DOCKETED	
Docket Number:	23-OPT-02
Project Title:	Darden Clean Energy Project
TN #:	255082
Document Title:	CEC Data Request Response Set 2
Description:	<p>Provides the Applicant's second response set to data requests received from the CEC. Responses address data requests related to Hazards and Hazardous Materials, Project Description, Socioeconomics, Traffic and Transportation, Transmission System and Design, and Waste. The document includes the following appendices to support responses:</p> <ul style="list-style-type: none"> - Appendix A DR HAZ-7 Industrial Lithium-Ion Battery Emergency Response Guide - Appendix B DR TRANS-5 Preliminary Helicopter Use Plan - Appendix C DR TRANS-7 Transportation Analysis Supplement - Appendix D DR TSD-2 Substation and Switchyard Diagram - Appendix E DR TSD-4 Grounding Detail
Filer:	Evelyn Langsdale
Organization:	Rincon Consultants
Submitter Role:	Applicant Consultant

Darden Clean Energy Project (23-OPT-02)

CEC Data Request Response Set #2

Figure 1 DR HAZ-7 Typical BESS Fire Protection Layout

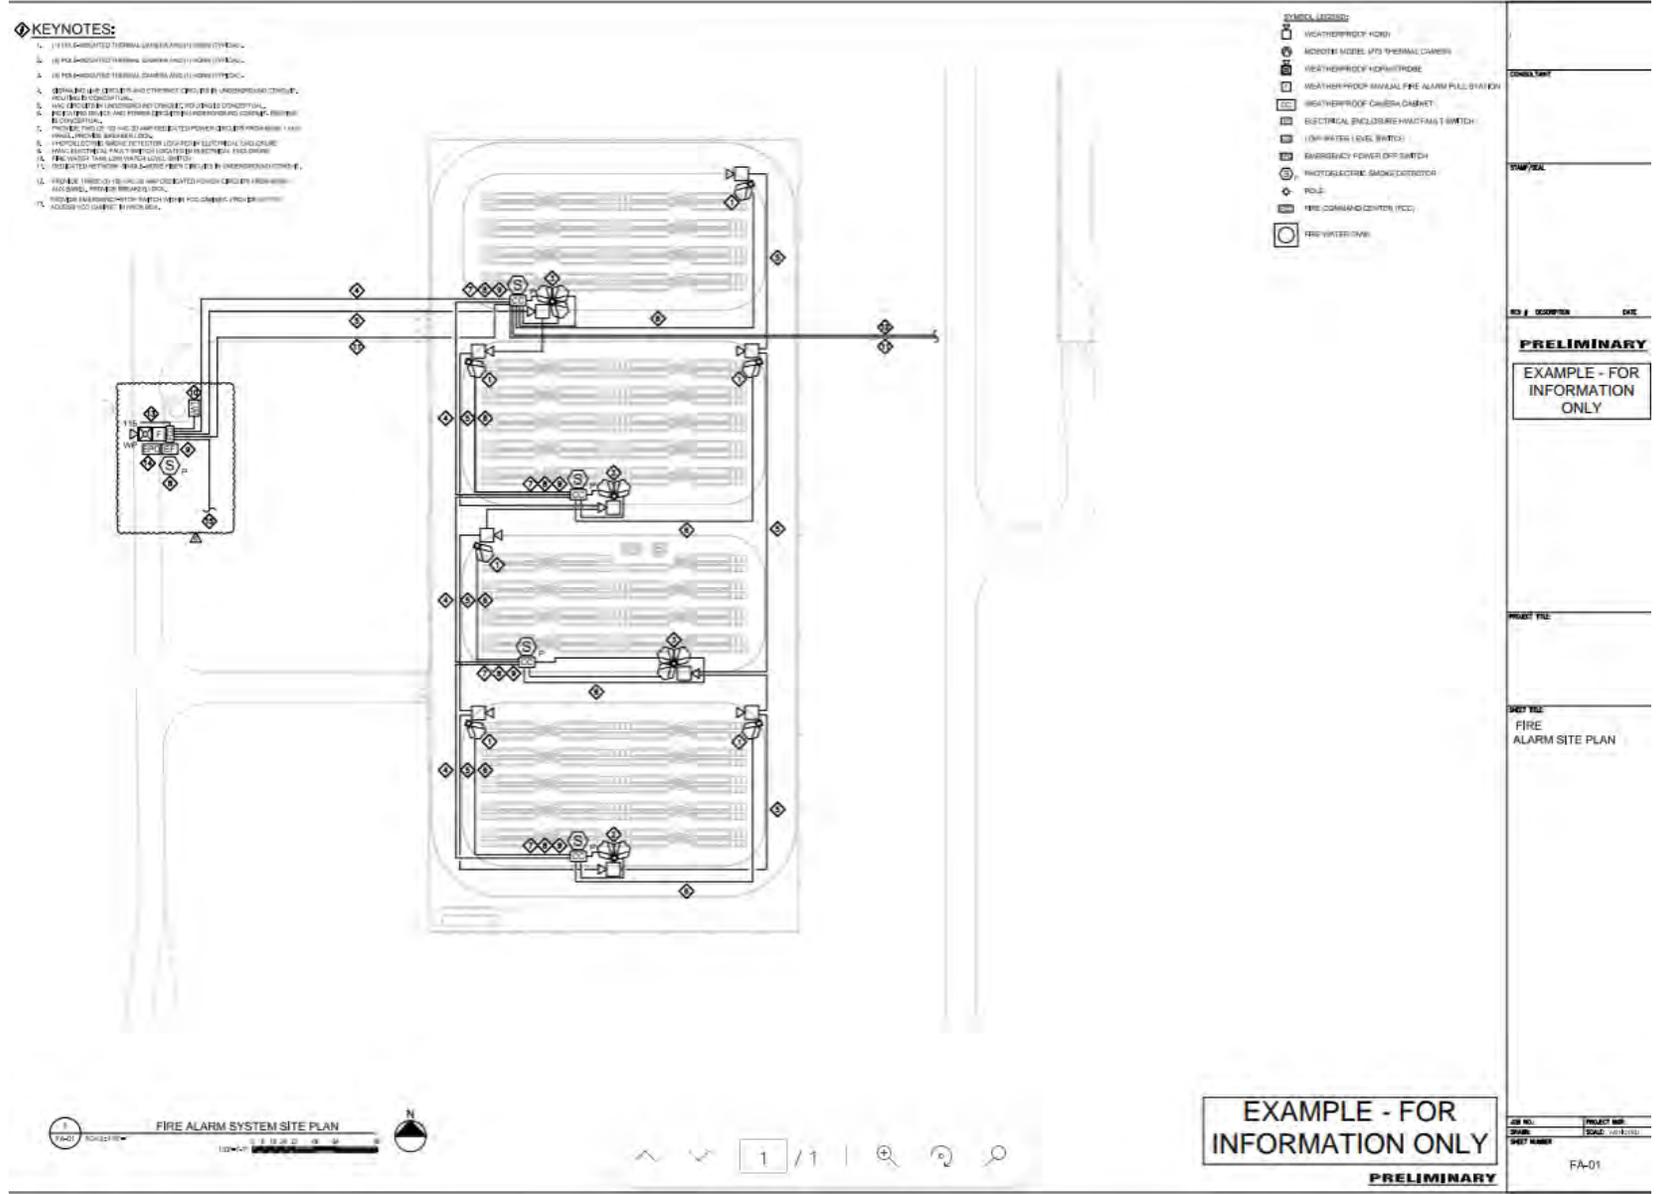
DR HAZ-7: Please provide a schematic site plan for the BESS that includes the locations for the emergency water storage. Please provide fire protection basis of design for BESS (similar to Appendix P for the hydrogen facility).

Response: The BESS facility will be designed using a UL9540A tested, modular, fully integrated, AC-coupled industrial BESS. The BESS will be connected to pad mounted transformers that step up the voltage to medium voltage levels, in-turn connecting to the Project substation through a feeder breaker. There will be up to four emergency 15,000-gallon water tanks for the Project. A typical BESS fire protection layout is provided in Figure 1 below. The final number and location of water tanks for emergency use will be determined in accordance with vendor requirements and the California Fire Code (CFC).

The BESS will comply with the current CFC, which governs the code requirements to minimize the risk of fire and life safety hazards specific to BESS used for load shedding, load sharing and other grid services (Chapter 12 Section 1206 of the 2019 CFC). In accordance with the CFC, the battery enclosure and the site installation design are all required to be approved by the local or State Fire Marshal. Potential hazards and procedures to follow in case of emergencies associated with the BESS are outlined in the Industrial Lithium-Ion Battery Emergency Response Guide, which is provided as Appendix A to this document.

Figure 2 DR PD-2 Green Hydrogen Stub Pipeline Potential Locations

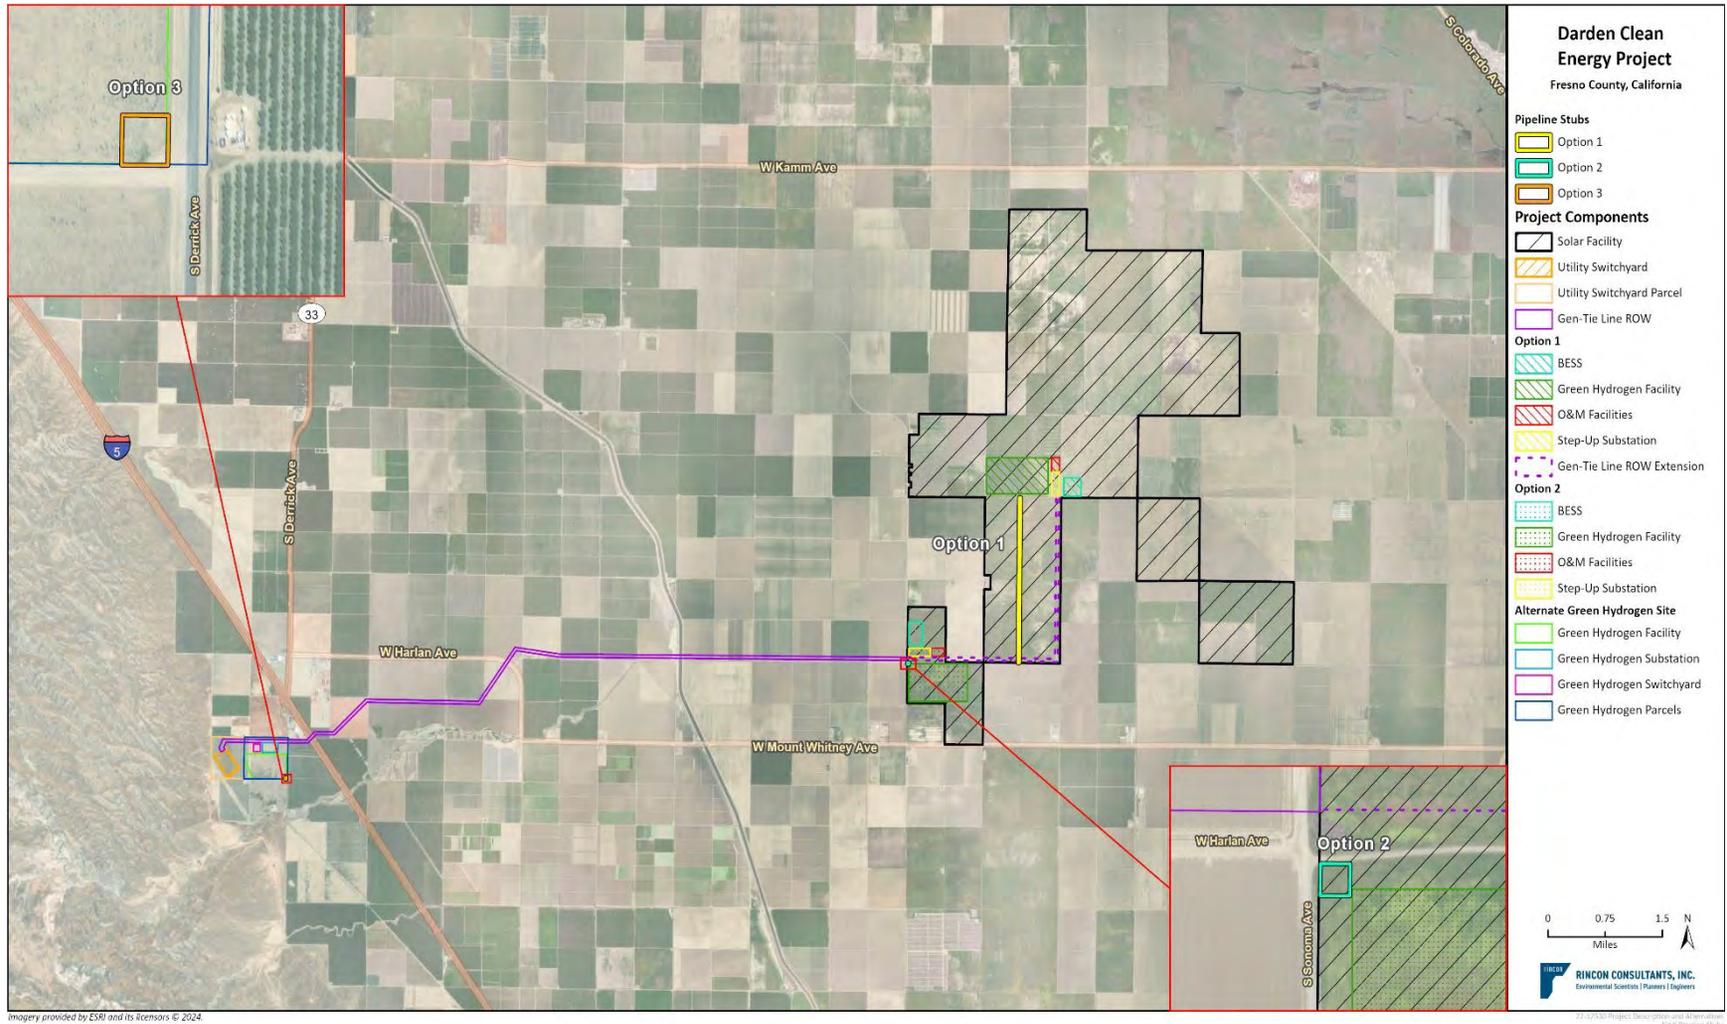
DR PD-2: Please describe where on the project site the green hydrogen stub pipeline would be proposed and confirm the approximate length and width of the corridor. Please show the location on a figure and GIS shape file.

Response: The stub pipeline locations have not been finalized and will be dependent on final design. A KMZ was provided via Kiteworks on March 14, 2024 and includes representative locations of the stubs at each proposed hydrogen location. These locations are also illustrated in Figure 2 below. The stub pipelines will lead from the hydrogen facility and end at the edge of the Project boundary where they will connect with the independent offtake pipeline. The permanent corridor within the Project site may be up to approximately 90 feet wide. The length of the corridor may range from several hundred feet to up to 2 miles.

Figure 3 DR PD-11 Conceptual BESS Layout and Detail

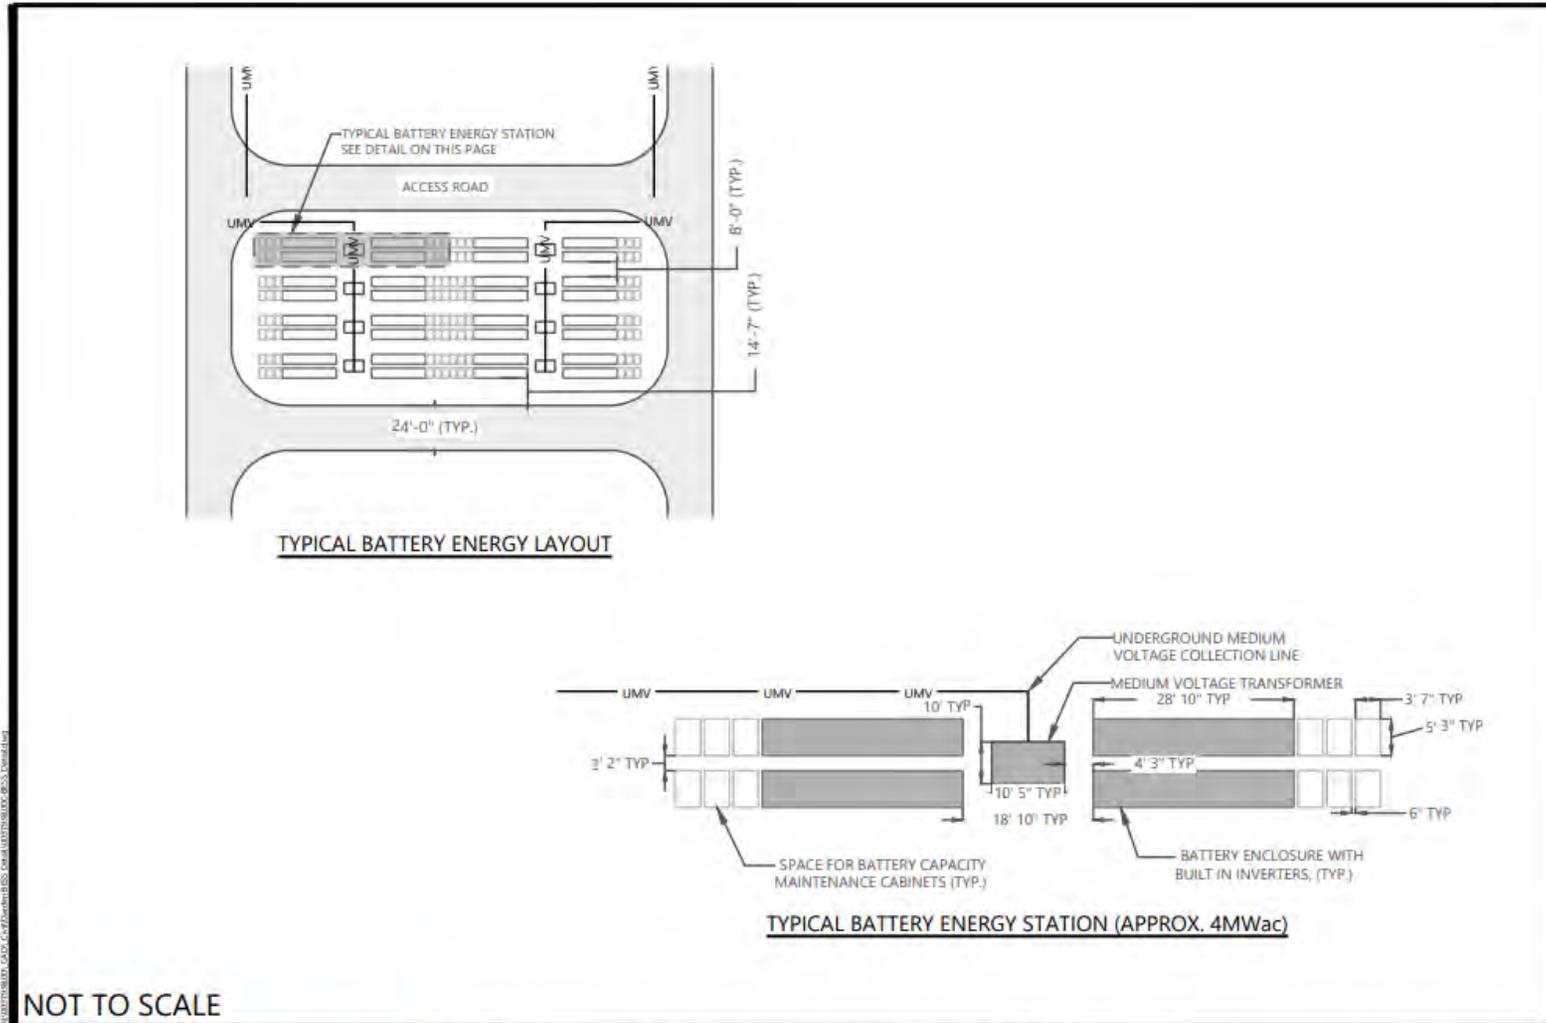
DR PD-11: Please provide a site plan with layout for the BESS, including but not limited to number of battery systems, BESS arrangement, access roads and pathways.

Response: A conceptual site plan with a typical BESS layout is provided as Figure 3 below. The energy storage system will consist of lithium-ion battery banks housed in electrical enclosures and buried electrical conduit. As detailed Project design and engineering continues and the size of the storage system is finalized, a battery vendor will be selected and details of the lithium-ion technology and battery dimensions will be determined. Between 610 and 1,220 electrical enclosures will be installed on level foundations for the Project. The enclosures will be connected to pad mount transformers that step up the battery voltage to medium voltage levels, and will connect to the Project substation through feeder breakers. The layout of the BESS will entail blocks of 4 to 6 battery energy stations surrounded by access roads, with each energy station consisting of 2 to 4 battery enclosures and 1 medium voltage transformer.
